VALUE ENGINEERING STUDY

Project # CSSTP-0006-00(252) PI No. 0006252
Project # CSSTP-0006-00(253) PI No. 0006253

**S.R. 44 from US 441 to I-20
Putnam/Greene County, Georgia**

6 December 2012

PROPOSAL NUMBER: B2-5

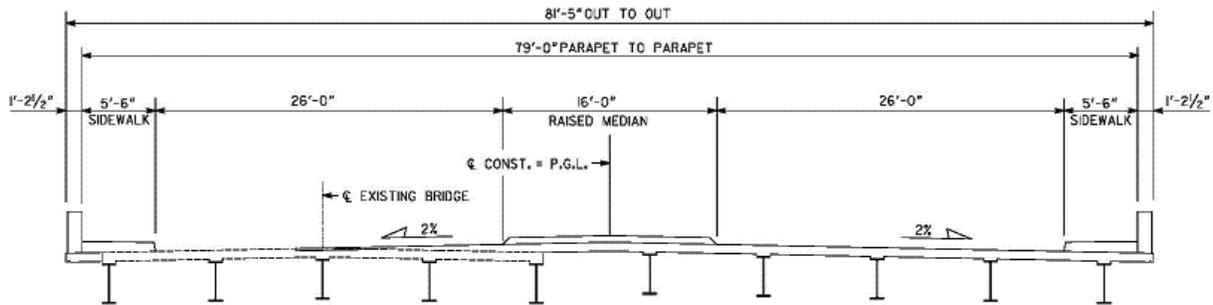
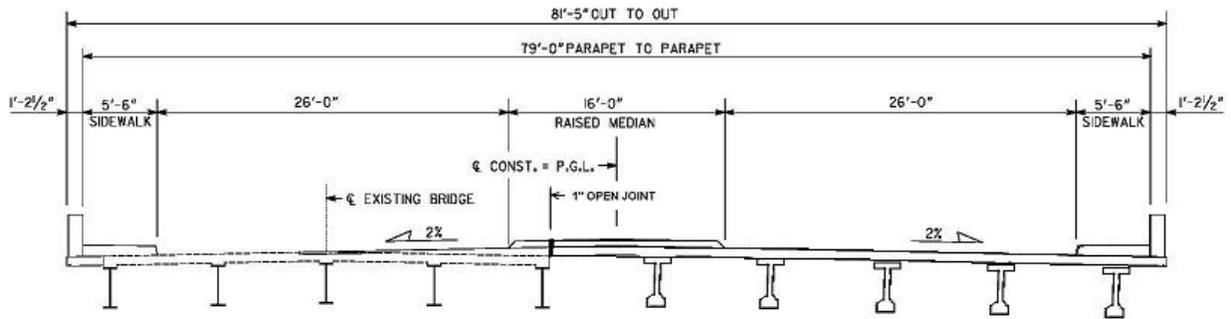
PROPOSED CHANGE: It is proposed to build the widened portion of the bridge with prestressed beams and have an open joint in the median to separate the different structures.

PROPOSAL NUMBER: B2-6

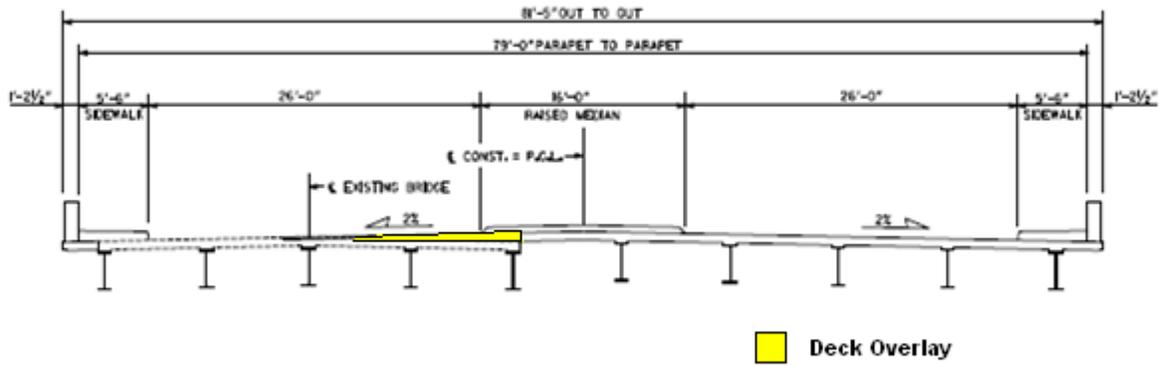
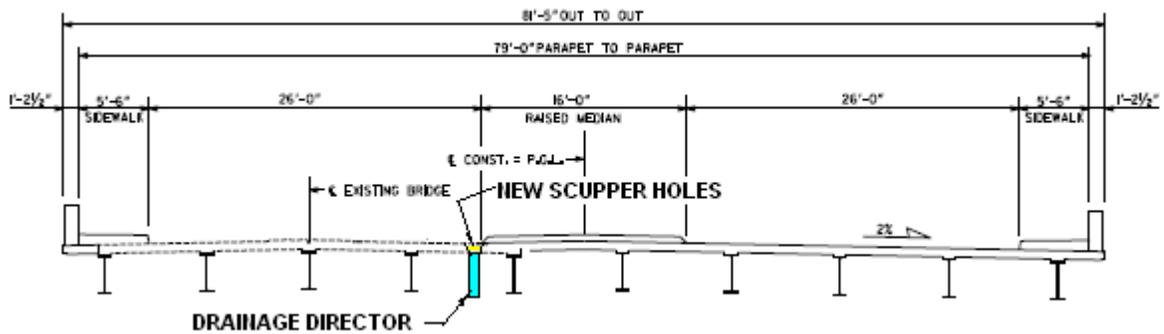
ORIGINAL DESIGN: The existing bridge over Lick Creek is crowned in the middle. The current project design builds a parallel bridge and overlays the existing bridge deck to change the bridge to superelevated in one direction.

PROPOSED CHANGE: It is proposed to eliminate the overlay of the existing bridge deck. Also, cut new scupper holes at the edge of the median and install a pipe director to channel the bridge drainage below the superstructure (if necessary) to drain the deck. Otherwise, allow the water to drain off the deck and catch it in a drainage structure at the bridge end.

JUSTIFICATION: Traffic on the west bound bridge (existing bridge) doesn't require a constant cross slope. The crowned bridge can remain. The concern is the drainage to the median. With the barrier being replaced with a raised median, the existing scupper holes will be covered up. This alternative would provide the ability to drain the deck in approximately the same place and direct it away from splashing on the superstructure (if required by design).

PROPOSAL NUMBER: B2-7

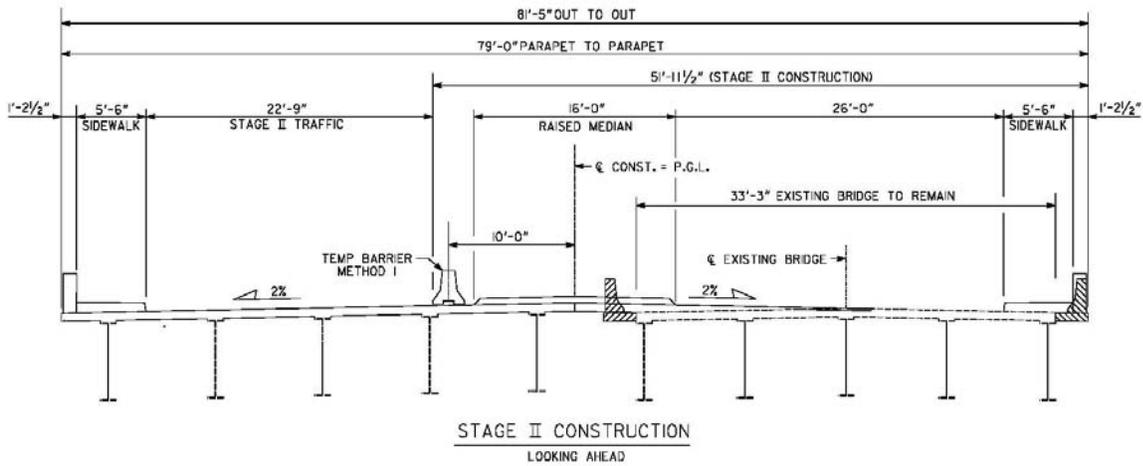
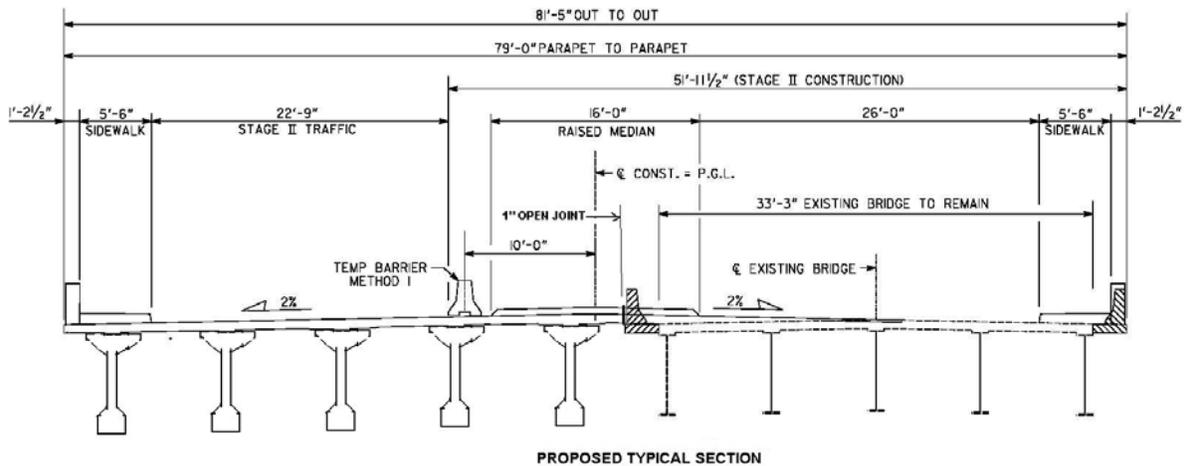
PROPOSED CHANGE: It is proposed to widen the bridge with prestressed beams and keep the existing bridge and widened portion independent by means of a 1” open joint. Maintain the pier placement on the widened portion.

The sketch above shows the prestressed beam bridge adjacent to the existing steel bridge. Number and size of beams are shown for illustrative purposes only.

PROPOSAL NUMBER: R2-1

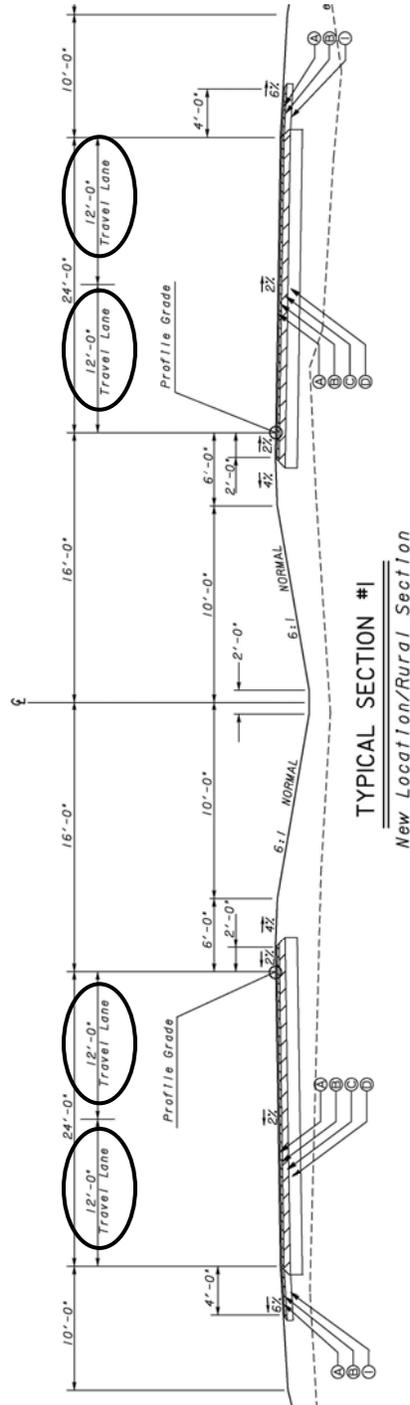
PROPOSED CHANGE: It is proposed to reduce all travel lanes on the rural sections from 12' to 11'.

Proposed Change: Revise 12'0" travel lanes to 11'0"

PROPOSAL NUMBER: R2-1.1

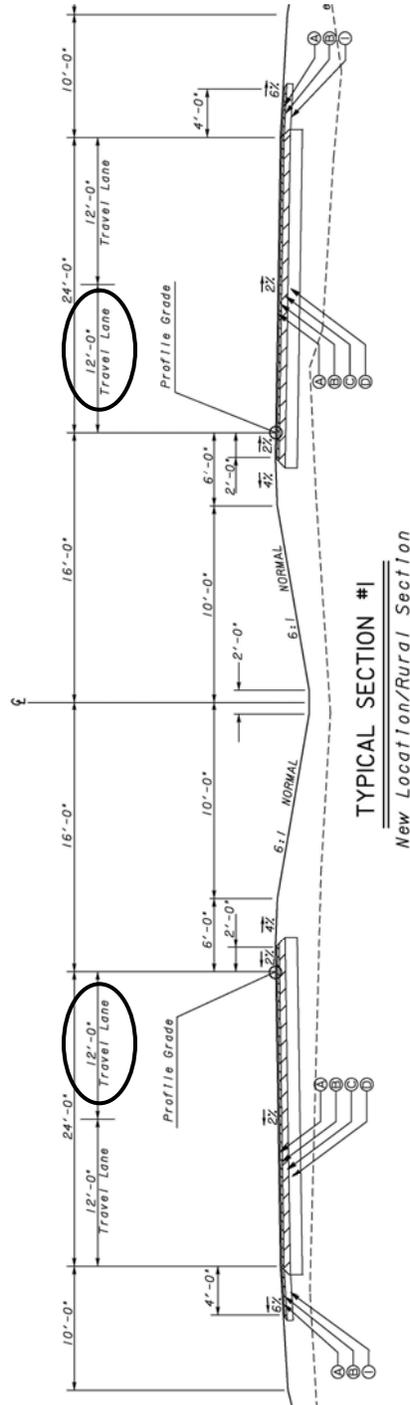
PROPOSED CHANGE: As an alternative to proposal R2-1, it is proposed to reduce the inside travel lanes on the rural sections from 12' to 11' while maintaining the 12' width on the outside lanes.

Proposed Change: Reduce inside travel lanes from 12'0" to 11'0"

PROPOSAL NUMBER: R2-2

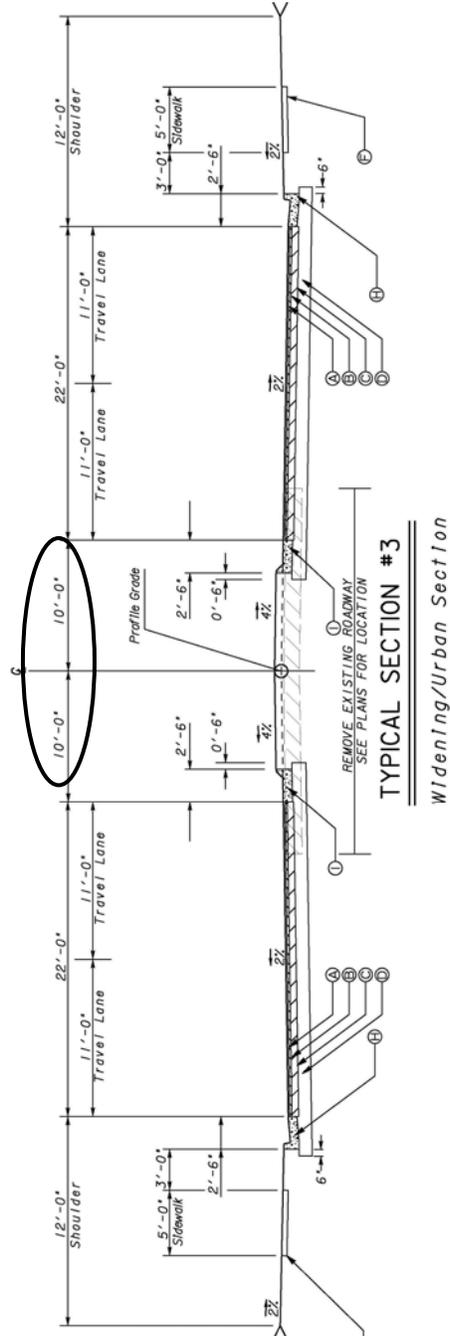
PROPOSED CHANGE: It is proposed to change the width of the raised median from 20 feet to 16 feet for urban sections #3 and #4.

Proposed Change: Reduce 20'0" median to 16'0"

PROPOSAL NUMBER: R2-4

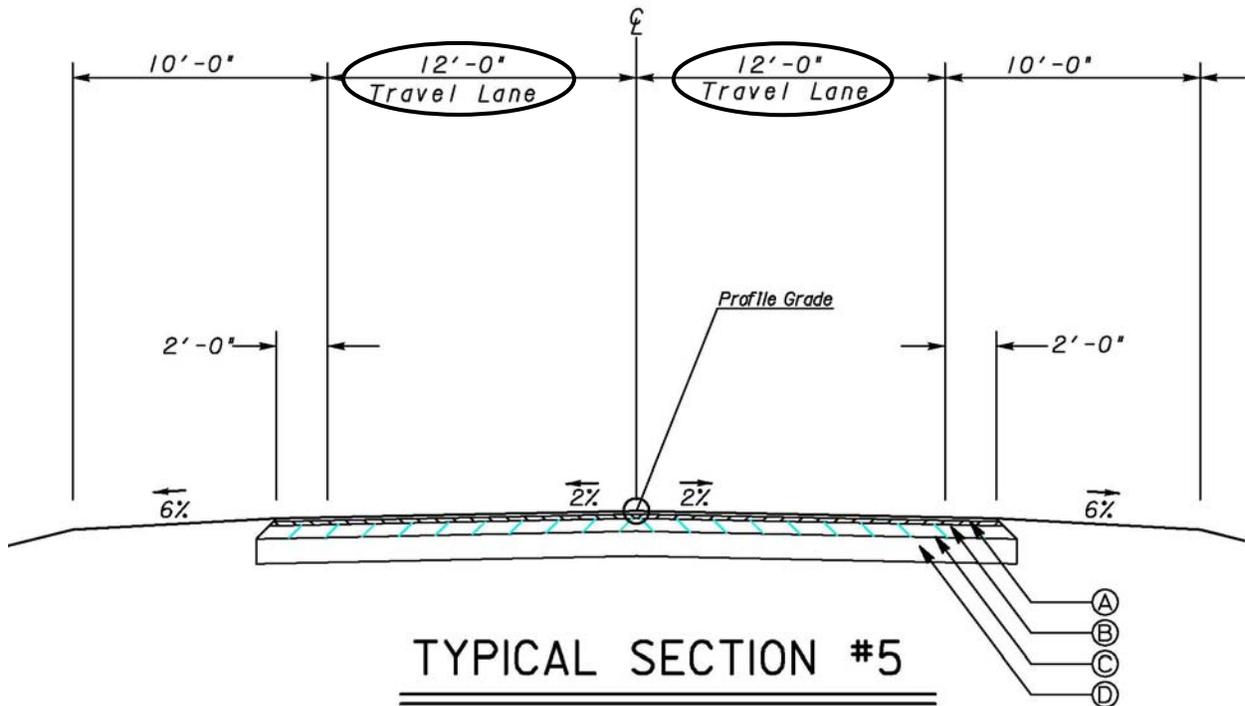
PROPOSED CHANGE: It is proposed to reduce all travel lanes on the side street sections from 12' to 11'.

JUSTIFICATION: Based on the current plans, the existing side streets appear to be less than 12' in lane width and GDOT design policy allows 11' lanes for local roads as indicated on Table 6.4 of the Design Policy Manual.

Proposed Change: Revise 12'0" travel lanes to 11'0"

PROPOSAL NUMBER: R2-5

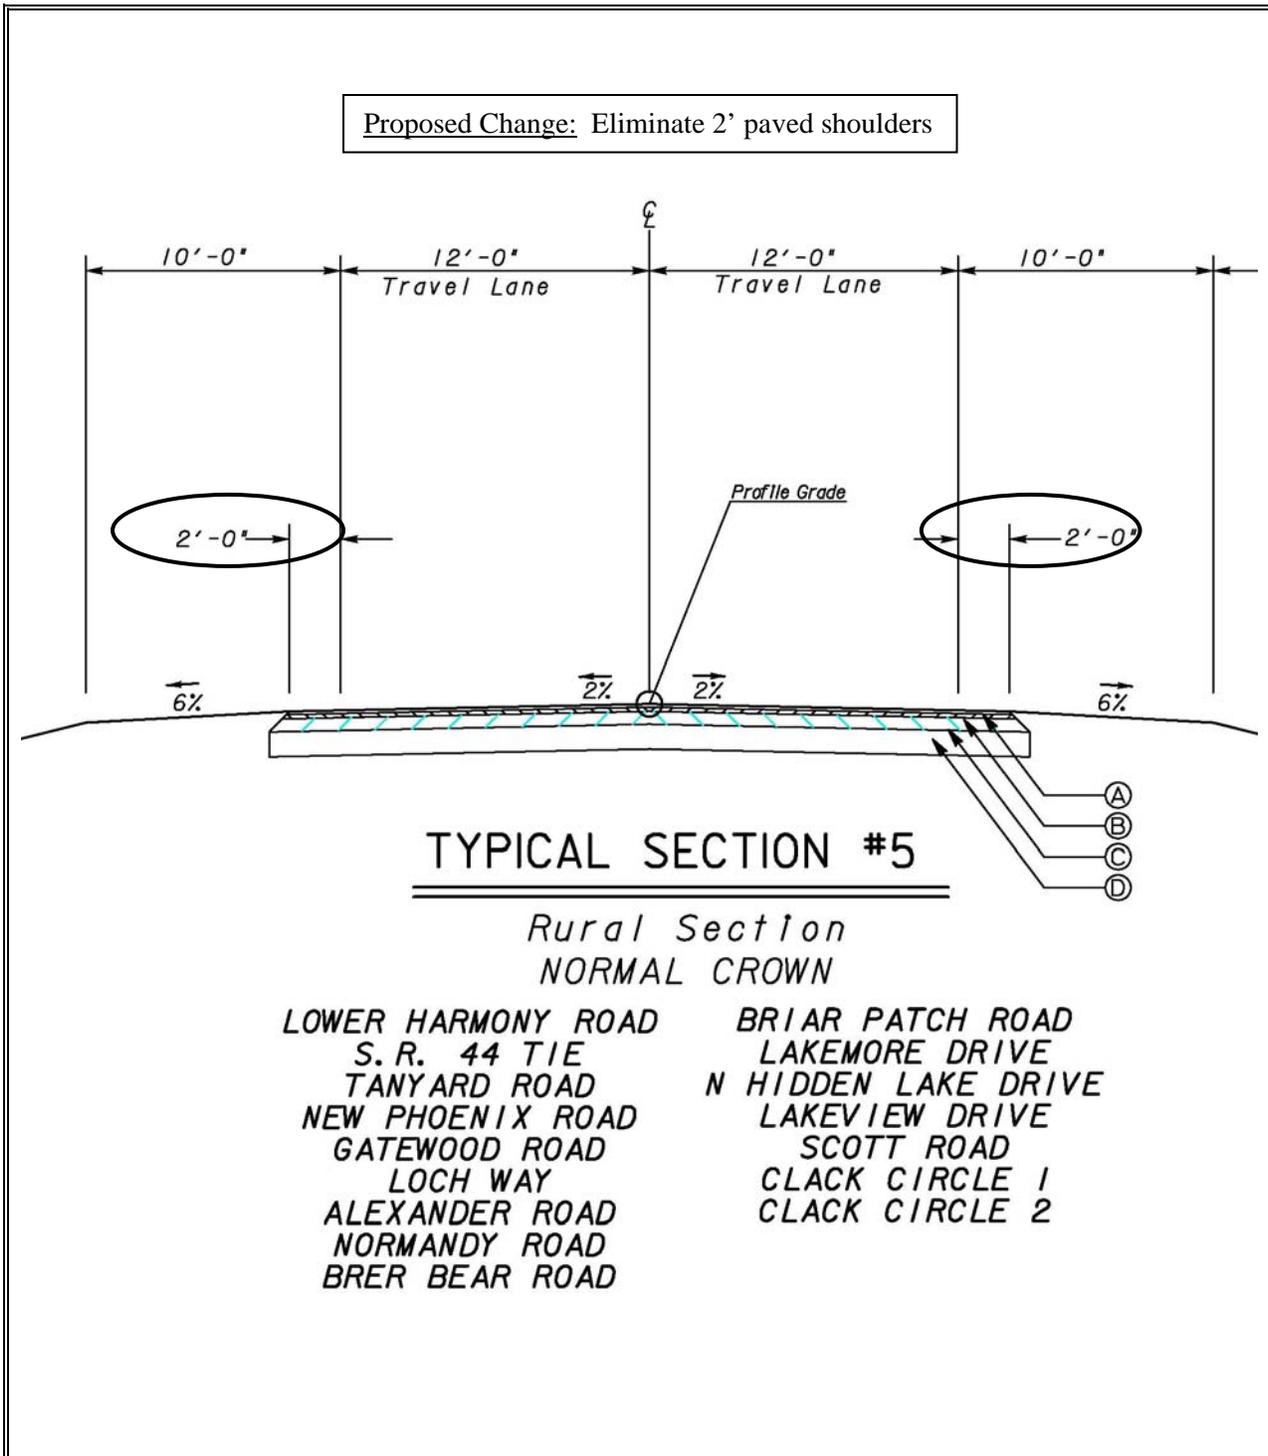
PROPOSED CHANGE: It is proposed to eliminate the 2' paved shoulders on the rural side street sections.

PROPOSAL NUMBER: R2-7

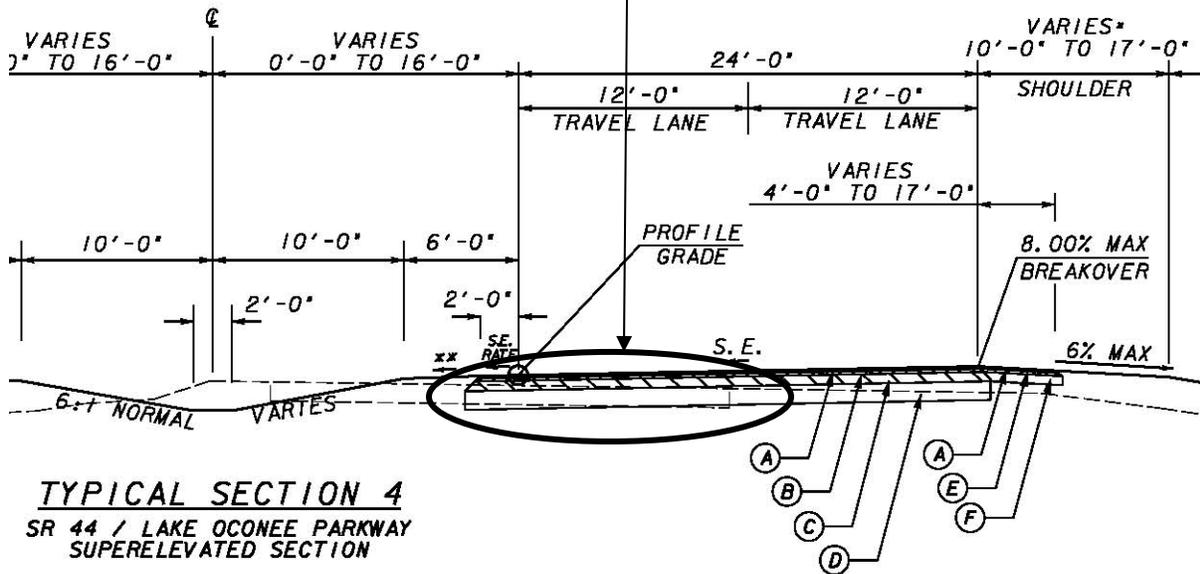
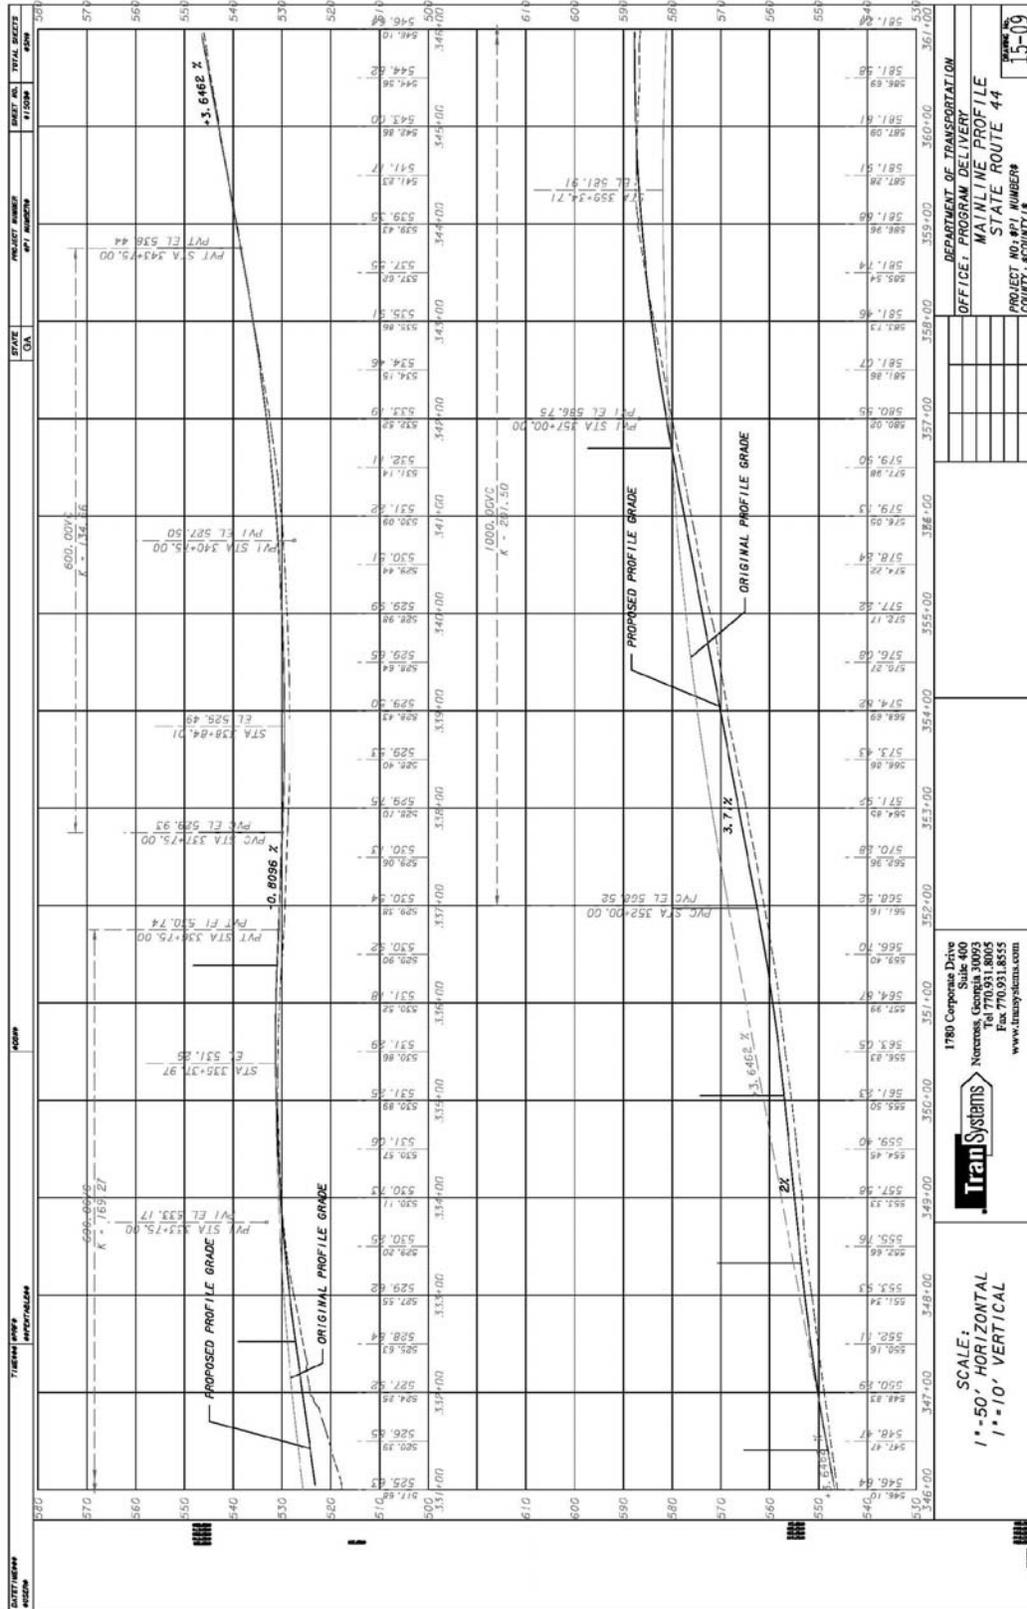
PROPOSED CHANGE: It is proposed to utilize the existing pavement in lieu of full depth pavement from approximate Sta 332+00 to approximate Sta 359+00 and from approximate Sta 485+00 to approximate Sta 734+00.

JUSTIFICATION: An existing pavement evaluation has not been completed, but based on photo evidence the existing pavement appears usable. The profile for SR44 can be revised to closer match the existing and will meet the required 55 mph design speed in the rural section, 45 mph design speed in the urban section and will meet the requirements of GDOT and AASHTO.

Proposed Change: Overlay where possible in lieu of full pavement section

PROPOSAL NUMBER: R2-8

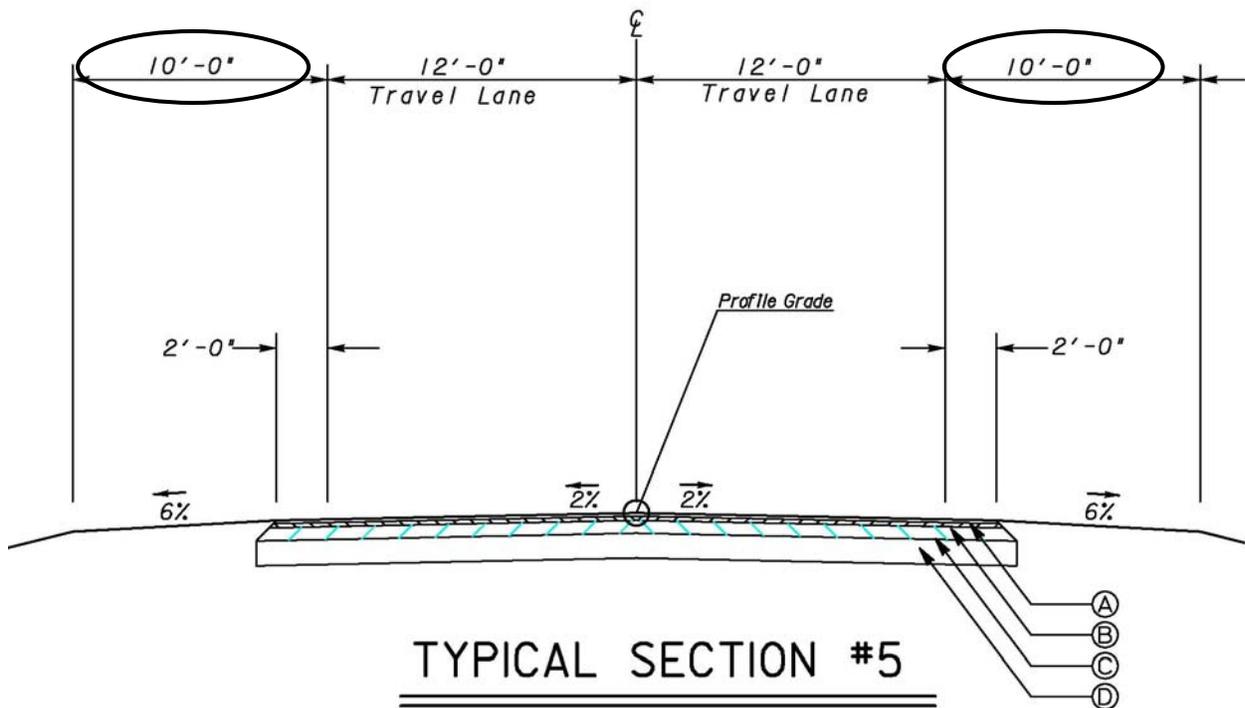
PROPOSED CHANGE: It is proposed to reduce the total shoulder width on the rural side street sections from 10' to 8'.

Proposed Change: Reduce total shoulder width from 10' to 8'
